MODIFICATION INSTRUCTIONS for the *Kodak X-Omat* MULTILOADER 300 Service Code 3058 Modification No. 27

Kodak X-Omat 270 RA PROCESSOR Service Code 3059 Modification No. 18

Purpose:

Installing the New SPRINGS in the CROSSOVERS

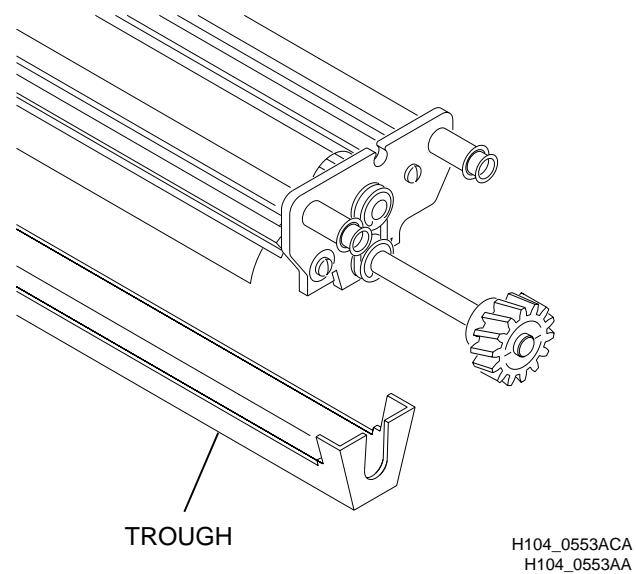
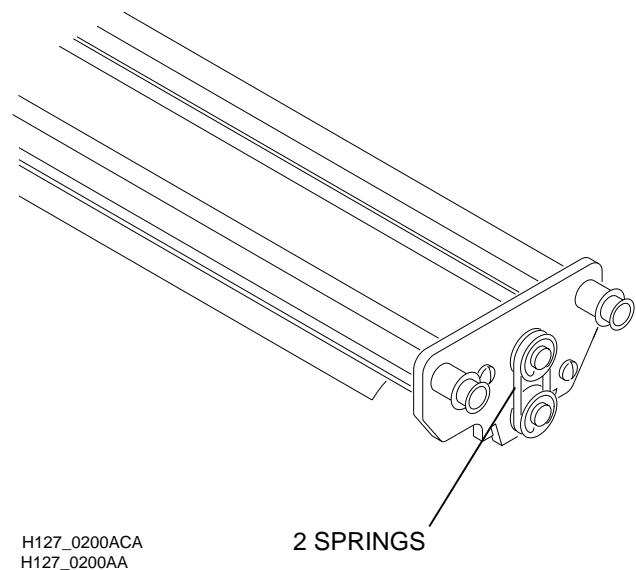
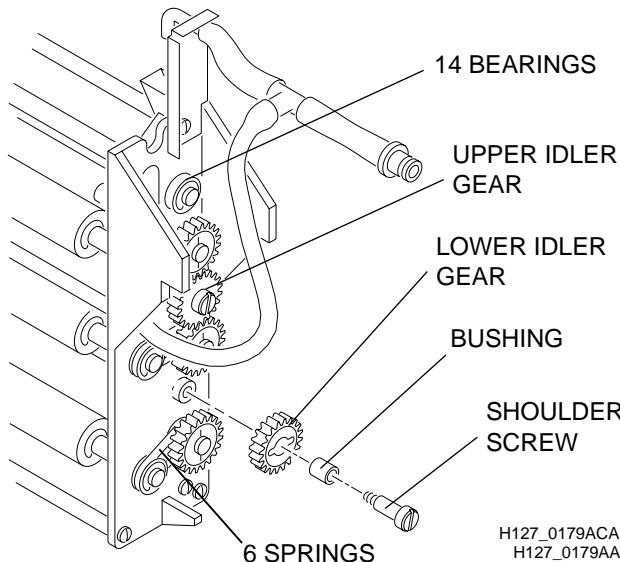
- [2] Remove and discard the 2 SPRINGS from the DEVELOPER/FIXER CROSSOVER and the FIXER/WASH CROSSOVER.
- [3] Install the 2 new SPRINGS, Part No. 1C7106, in both the DEVELOPER/FIXER CROSSOVER and the FIXER/WASH CROSSOVER.
- [4] Install the TROUGHS on the CROSSOVERS.

Section 4: Installing the New Replenishment FITTINGS

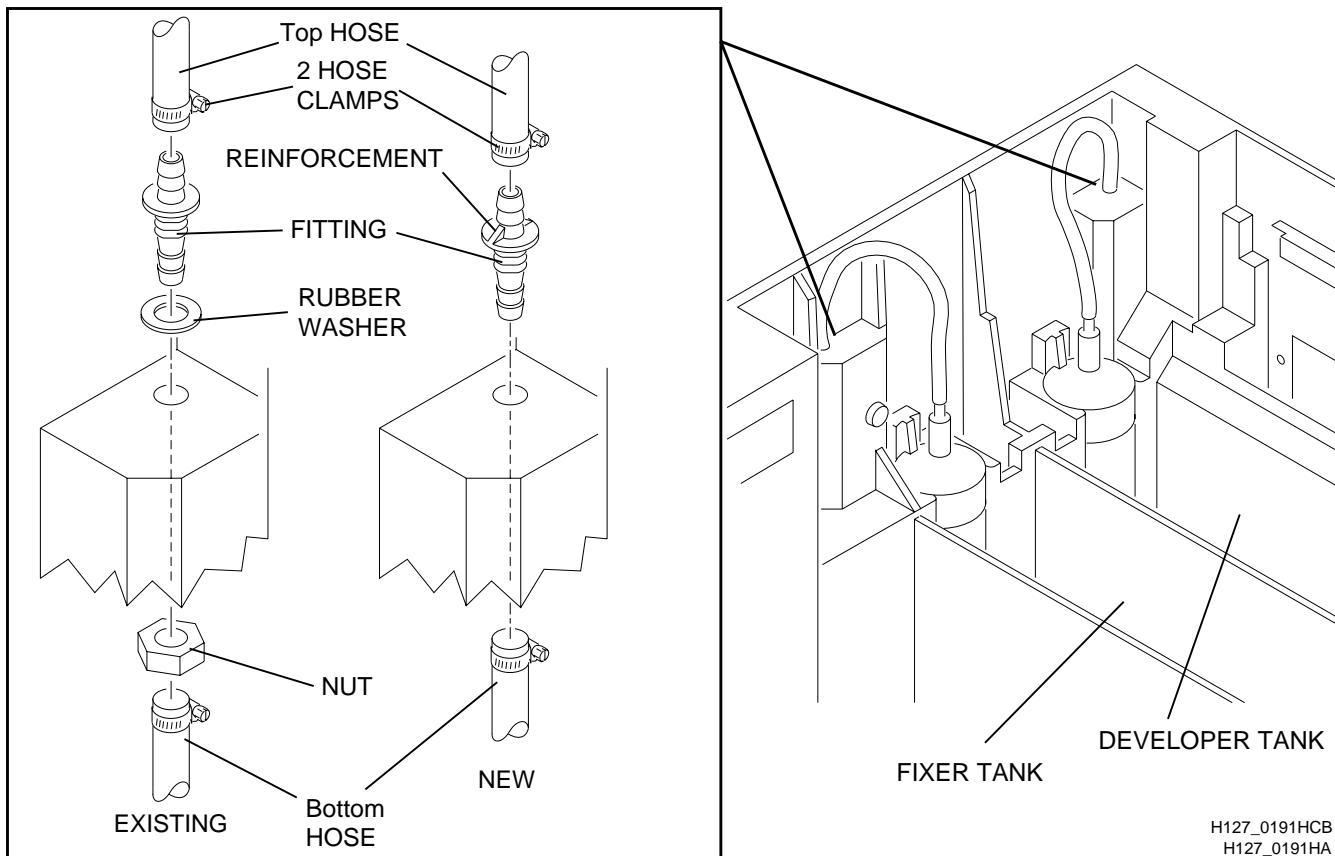
- [1]** Remove the existing FITTING, RUBBER WASHER, and NUT for the DEVELOPER and FIXER TANKS by doing the following for each FITTING:

- Loosen and disconnect the top and bottom HOSE CLAMPS.
- Remove the HOSE from each of the FITTINGS.
- Remove and discard the:
 - NUT
 - FITTING
 - RUBBER WASHER

- [2]** Install the new FITTINGS for the DEVELOPER and FIXER TANKS as follows:

- Install the FITTING between the top and bottom HOSE.
- Tighten the top and bottom HOSE CLAMPS to fasten the new FITTING.

Installing the New BARBED FITTINGS

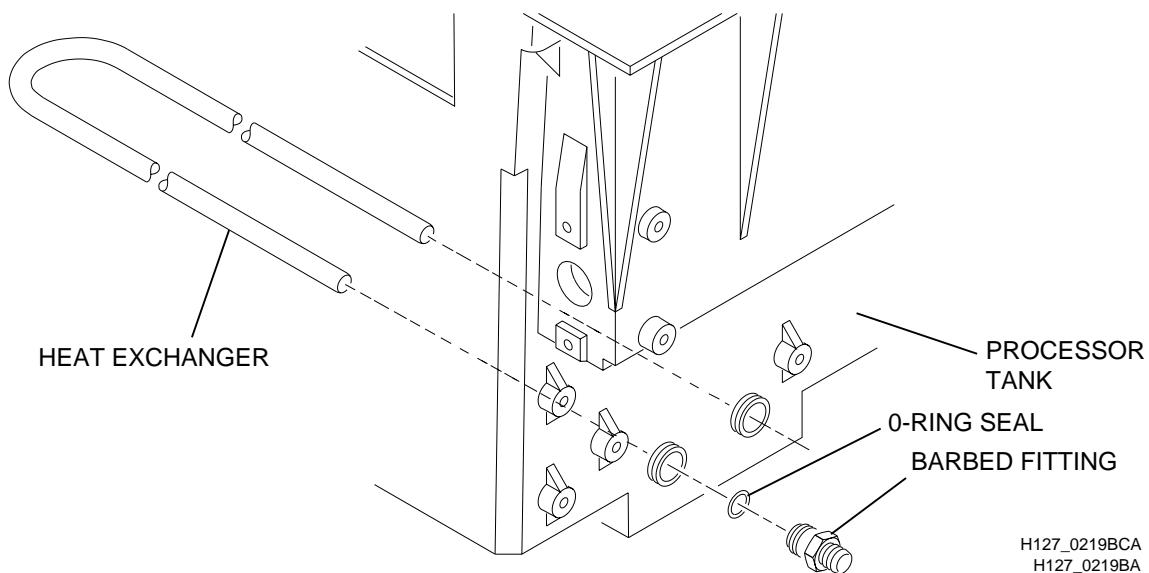
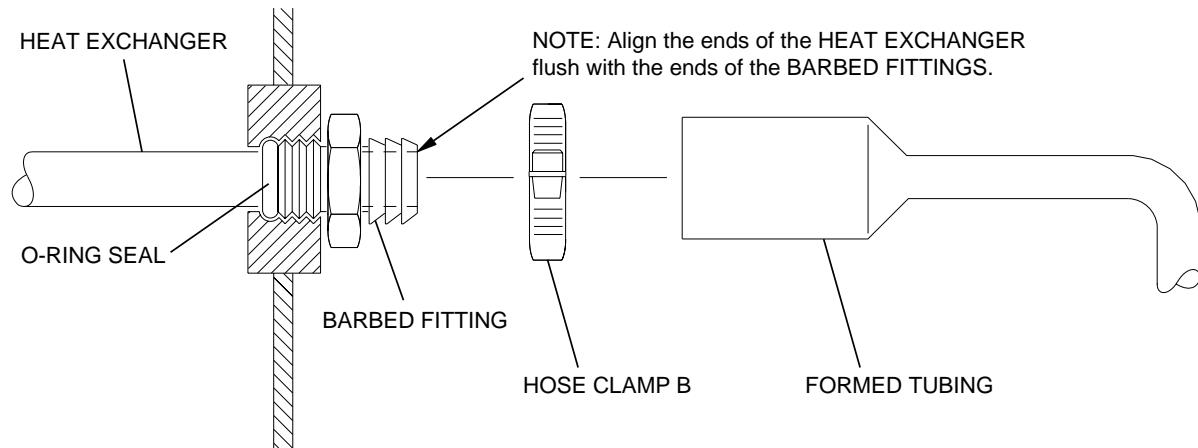
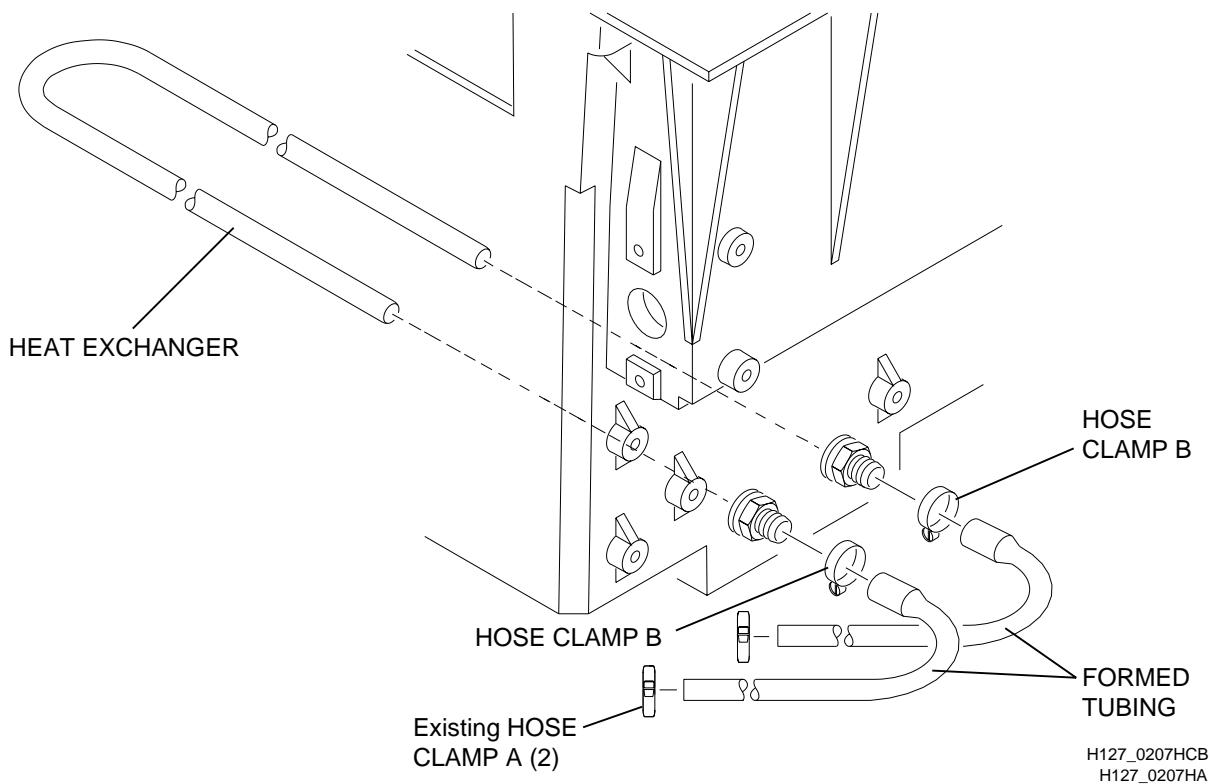
- [1] Place the ends of the HEAT EXCHANGER through the holes in the side of the PROCESSOR TANK.
- [2] Place a new O-RING SEAL on each end of the HEAT EXCHANGER.

- [3] Place a new BARBED FITTING onto each end of the HEAT EXCHANGER.
- [4] Loosely rotate the new BARBED FITTINGS into the holes in the side of the PROCESSOR TANK.

Do not tighten the BARBED FITTINGS more than necessary to correctly seat the O-RING SEALS. Incorrect installation of the BARBED FITTINGS will cause damage to the O-RING SEALS and fluid leakage.

- [5] Align the ends of the HEAT EXCHANGER flush with the ends of the BARBED FITTINGS and tighten the BARBED FITTINGS.

Section 6: Installing the New WASH TANK CLIP

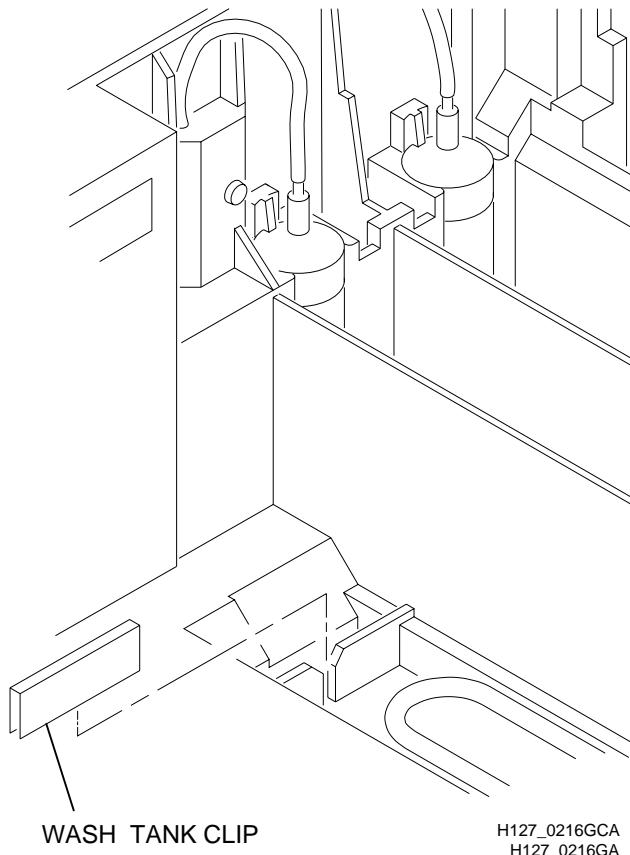
- [1] Remove and discard the existing WASH TANK CLIP.
- [2] Install the new WASH TANK CLIP.
